**MONTGOMERY COUNTY HISTORIC PRESERVATION COMMISSION**  
**STAFF REPORT**

<b>Address:</b>	29 Holt Place, Takoma Park	<b>Meeting Date:</b>	4/22/2026
<b>Resource:</b>	Contributing Resource Takoma Park Historic District	<b>Report Date:</b>	4/15/2026
<b>Applicant:</b>	Emily Suran (Richard Vitullo, Architect)	<b>Public Notice</b>	4/8/2026
<b>Review:</b>	HAWP	<b>Tax Credit:</b>	No
<b>Permit Number:</b>	1152653	<b>Staff:</b>	Devon Murtha

**PROPOSAL:** Removal of a tree and revisions to previously approved windows

Figure 4: Proposed rear elevation.

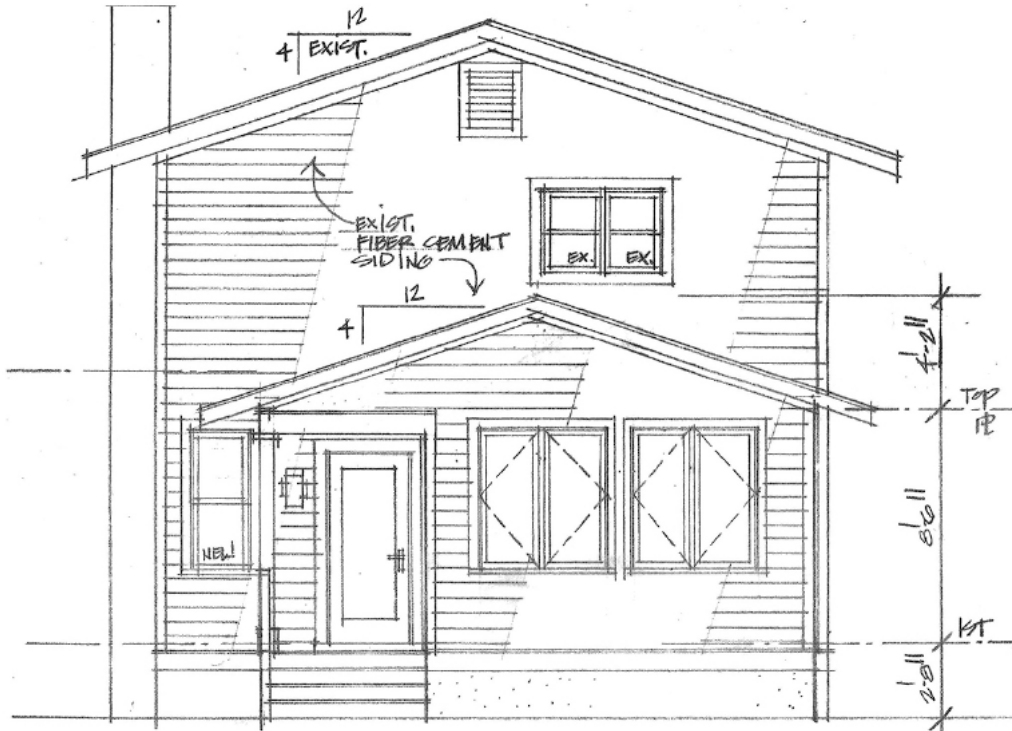
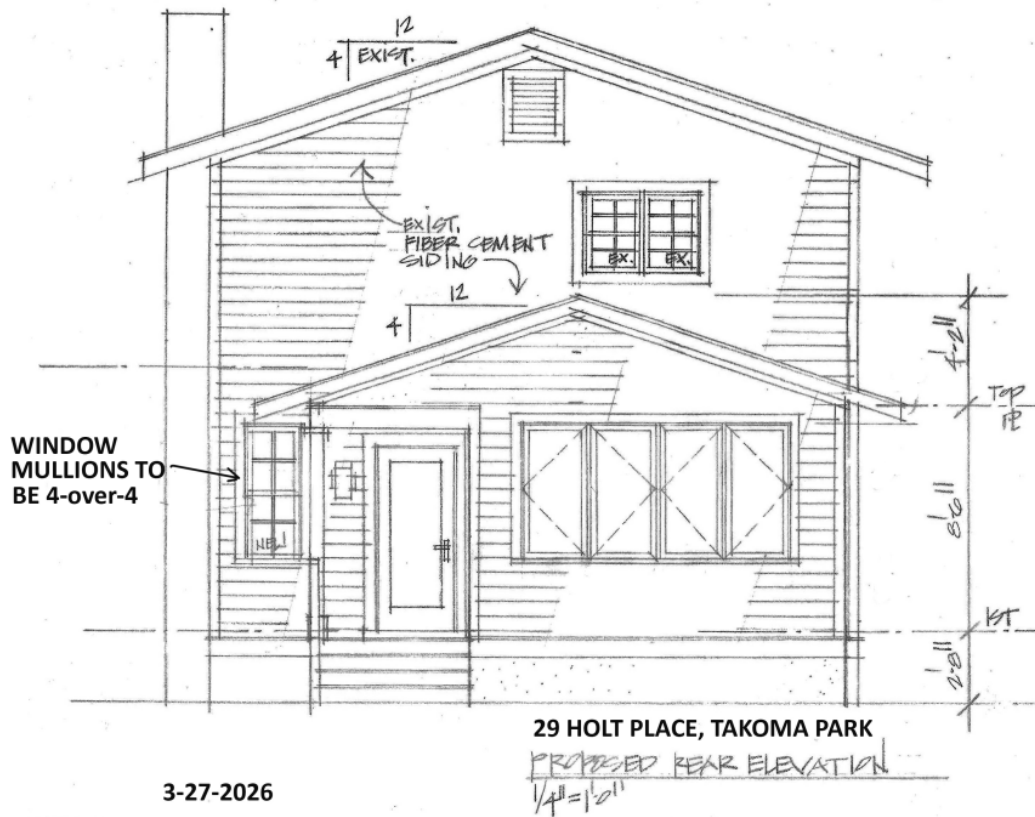
The applicant is also proposing to modify window details for the HAWP application approved at the March 11, 2026 meeting. The approved windows were new one-over-one aluminum-clad windows, and the proposed windows will be four-over-four and four-over-one aluminum-clad windows. All windows will be Mavin Elevate with 5/8" SDL ogee mullion bars.

Staff is also supportive of the proposed revisions to the fenestration. No historic windows will be impacted. Per the *Guidelines*, the design review emphasis will be restricted to changes that are at all visible from the public right-of-way. Although the overall massing of the approved addition will be visible from the right-of-way, the proposed fenestration revisions will be minimally visible, if at all, and should be reviewed with leniency. Staff finds that the proposed four-over-four and four-over-one windows are generally compatible with the overall character of the resource and recommends that this revision be approved, per the *Guidelines* and Chapter 24A-8(b).

29 HOLT PLACE, TAKOMA PARK  
PROPOSED REAR ELEVATION  
 $\frac{1}{4}'' = 1'-0''$

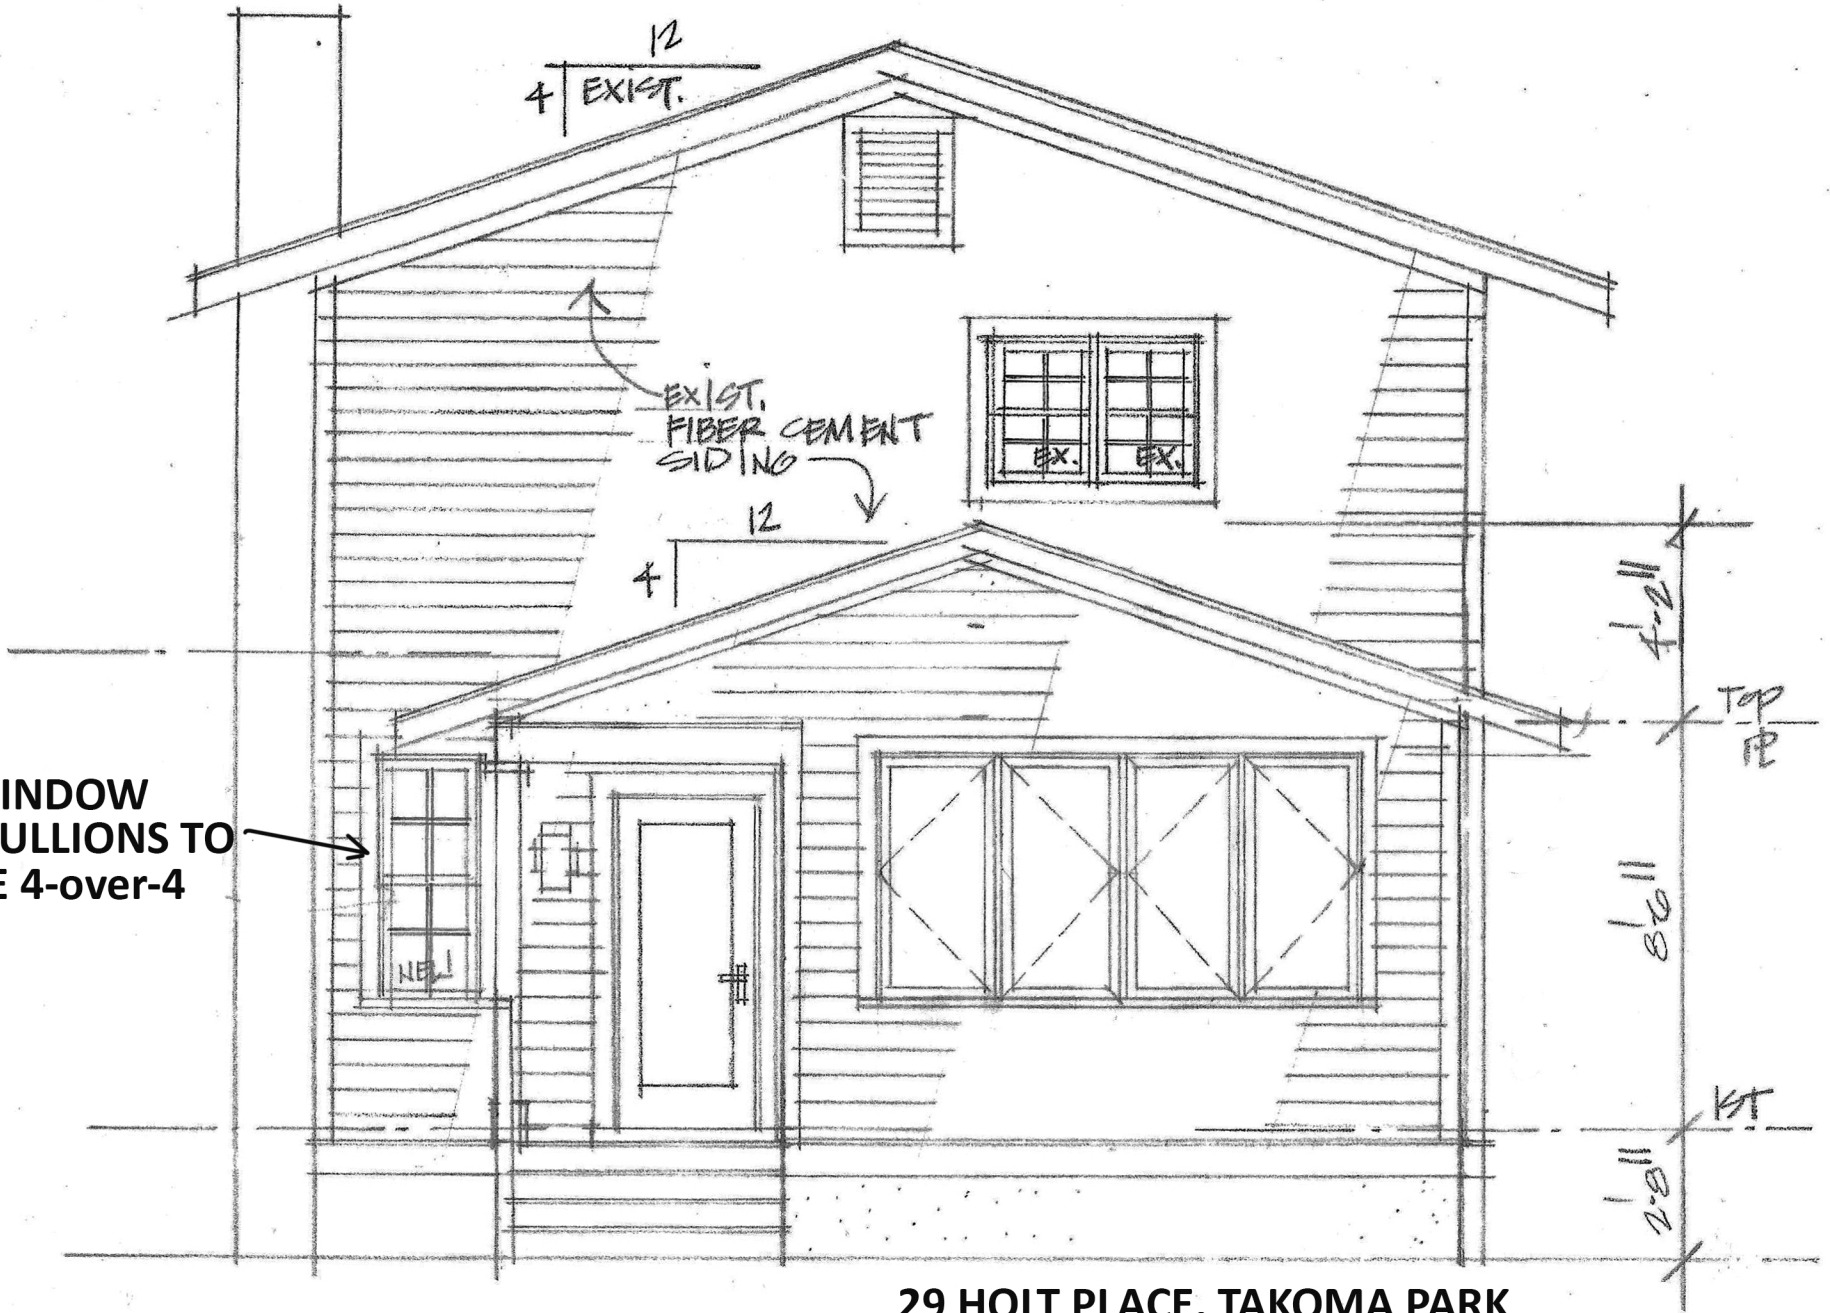
WINDOW  
MULLIONS TO  
BE 4-over-4
